Amendments to the Drawings:

REMARKS

Status of the Claims

FIG. 2

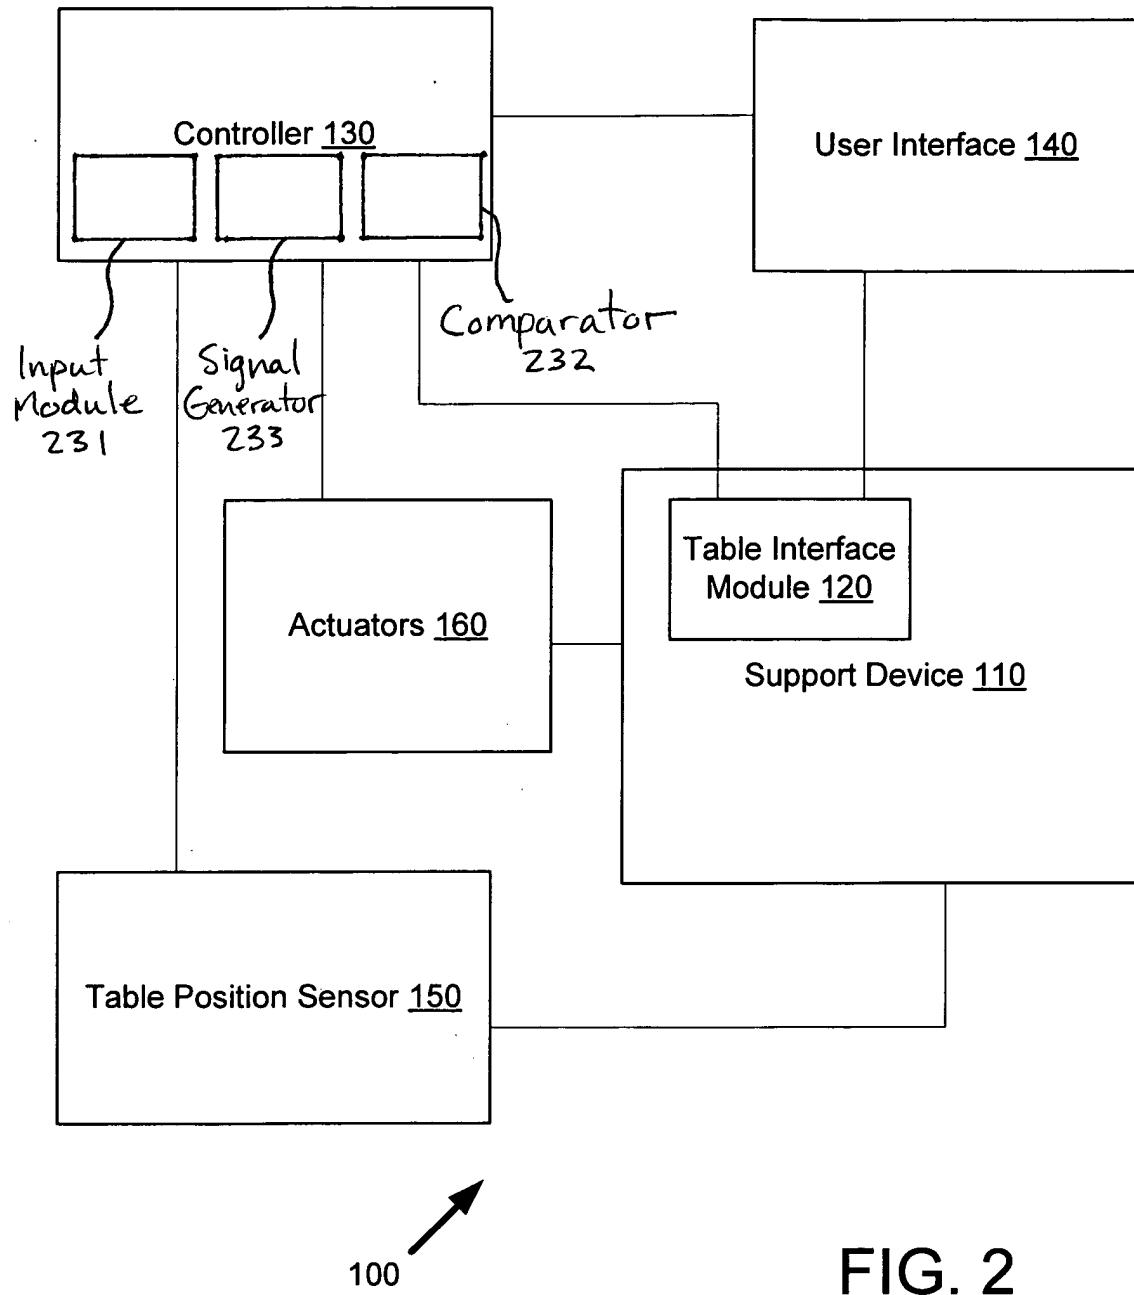
The drawings stand objected to under 37 C.F.R. 1.83(a) because the drawings must show every feature of the invention specified in the claims. In particular, the Office Action states that the "external device" as claimed in claim 11; "means for detecting" as claimed in claim 13; "means for deactivating" as claimed in claim 15; "an input module," "a comparator," "a signal generator" as claimed in claim 31; "a radiosurgical treatment apparatus," "an imaging system," "a robot" as claimed in claim 32; "an x-ray source," "articulated arm," "robot-based frameless stereotactic radiosurgery system" as claimed in claim 39; "gantry-based system" as claimed in claim 40 must be shown or the feature(s) canceled from the claim(s). Applicant respectfully submits that Figure 2 has been amended to include an input module 231, comparator 232, and signal generator 233. Support for these elements can be found in paragraphs 0024 and 0025 of the

Regarding “an external device,” Figure 2 illustrates actuators 160, which represents one embodiment for moving the table, in accordance with directions from the controller 130. External devices, such as a robot, may also be used for moving the table, in accordance with directions from the controller 130 via motion command signal. Accordingly, Figure 2 illustrates the external device. Support for this element can be found in paragraphs 0029 to 0031 of the specification.

Regarding “means for detecting,” Figure 2 illustrates a controller. The controller may include means for detecting handling errors or software control of the table. The support for this element can be found in paragraph 0032 of the specification.

Regarding “means for deactivating,” Figure 2 illustrates a controller. The controller may include means for deactivating the imaging system so as to prevent any further images from being acquired. The support for this element can be found in paragraph 0056.

The attached drawing sheet(s) include changes to Figure(s) 2. In Figure 2, controller 130 has been amended to illustrate input module 231, comparator 232, and signal generator 233. Support for these elements can be found in the specification, in particular in paragraph 0024. No new matter has been added.

specification. Amendments to the specification have also been amended to include reference numbers for those elements.
